- 2. Morning Panorama Subdivision #2; KPB File 2022-058**
Johnson Surveying / Rahman
Location: Morning Circle
Salamatof Area

ITEM 2 - MORNING PANORAMA SUBDIVISION #2

KPB File No.	2022-058
Plat Committee Meeting:	May 23, 2022
Applicant / Owner:	Hafiz Rahman of Salt Lake City, UT
Surveyor:	Jerry Johnson / Johnson Surveying
General Location:	Morning Circle, Salamatof area

STAFF REPORT

MORNING PANORAMA SUBDIVISION RICHEY REPLAT

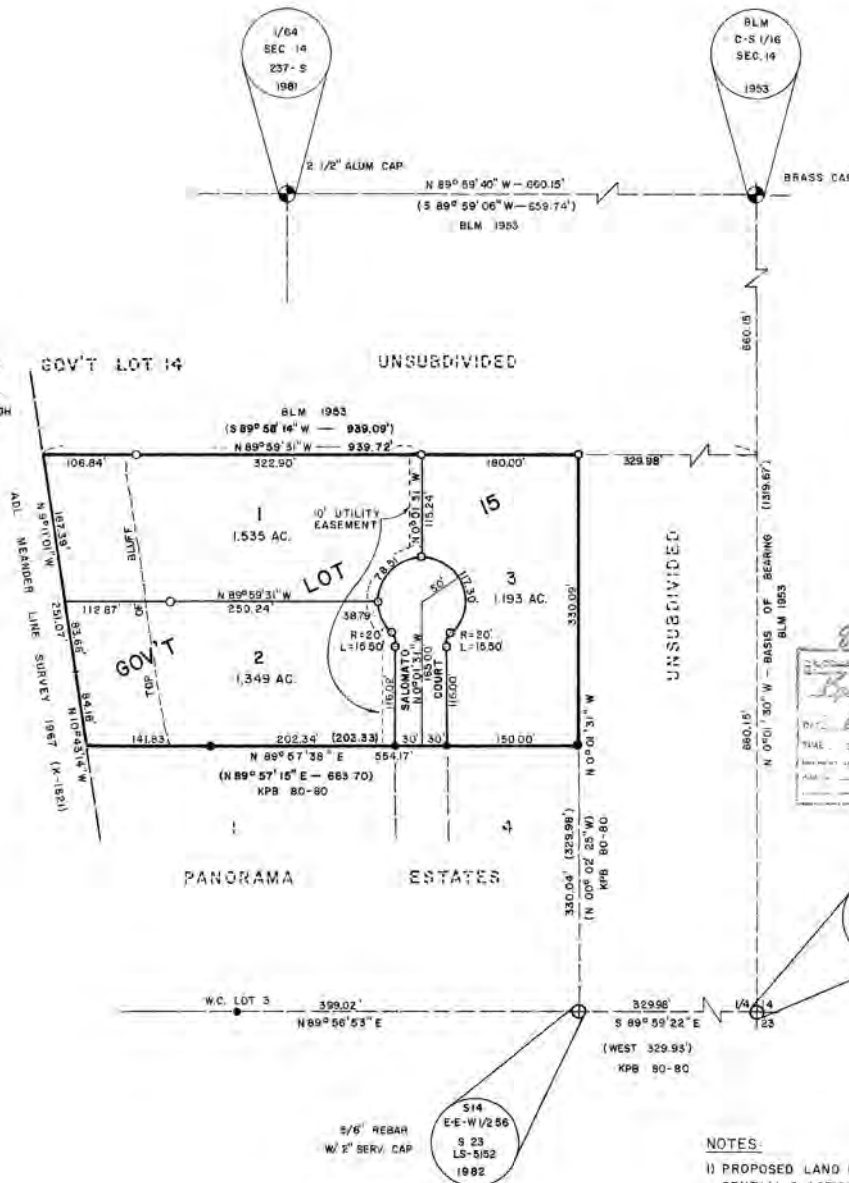
Correct plat note 5, the Book should be 206 and correct "file" to "filed".

Within plat note 5 and 6 capitalize "book" and "page" throughout the notes to be consistent.
